Access Compliance Report Public Rights-of-Way (Curb Ramps)

Main Street: HICKORY_BRANCH_RD		Cross Street: ALITA_LN		Location:	E
ADA ID: RPAT211109104253	Ramp Type: Type 4 - Parallel	Initial Pass/Fail: Fail	Overall Compliance: No	Severity Score:	15

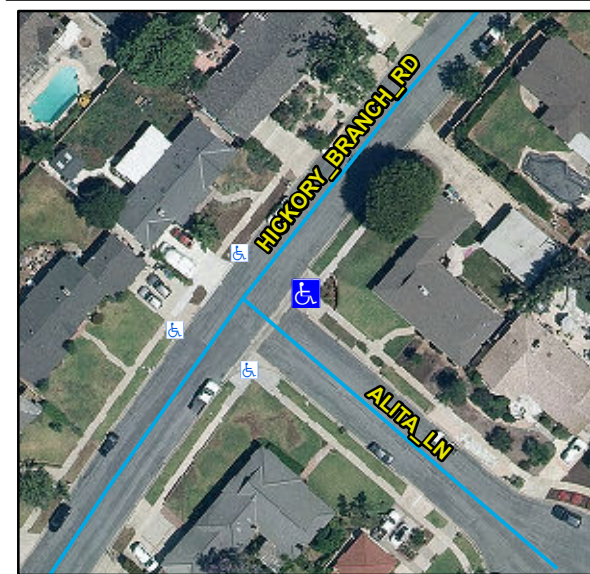
Compliance	Description	Data	Compliance	Description	Data
N/A	Ramp Length LT (in)	110	N/A	Ramp Length RT (in)	130
Yes	Ramp Width LT (in)	86	Yes	Ramp Width RT (in)	92
No	Ramp Run Slope LT (%)	8.5	Yes	Ramp Run Slope RT (%)	5.7
Yes	Ramp Cross Slope LT (%)	1.9	Yes	Ramp Cross Slope RT (%)	1.6
N/A	Landing Present	N/A	N/A	DWS Provided	N/A
N/A	Landing Length (in)	N/A	N/A	DWS Contrast	N/A
N/A	Landing Width (in)	N/A	N/A	DWS Length (in)	N/A
N/A	Landing Run Slope (%)	N/A	N/A	DWS Full Width	N/A
N/A	Landing Cross Slope (%)	N/A		DWS Offset Type	N/A
N/A	Landing Movement Obstructed?	N/A	N/A	DWS Offset Left (in)	N/A
	Landing Movement Type	N/A	N/A	DWS Offset Right (in)	N/A
N/A	Landing Shared	N/A			
N/A	Clear Space	Yes			
N/A	Clear Space To Crosswalk (in)	N/A			
N/A	Marked Crosswalk 1	No	N/A	Marked Crosswalk 2	No
	Crossing 1 Direction	NW		Crossing 2 Direction	SW
	Marked Crosswalk 1 Width (in)	N/A		Marked Crosswalk 2 Width (in)	N/A

Remove & Replace Curb Ramp With Two New Directional Ramps or Equivalent.

R304.3.2, STD 1115
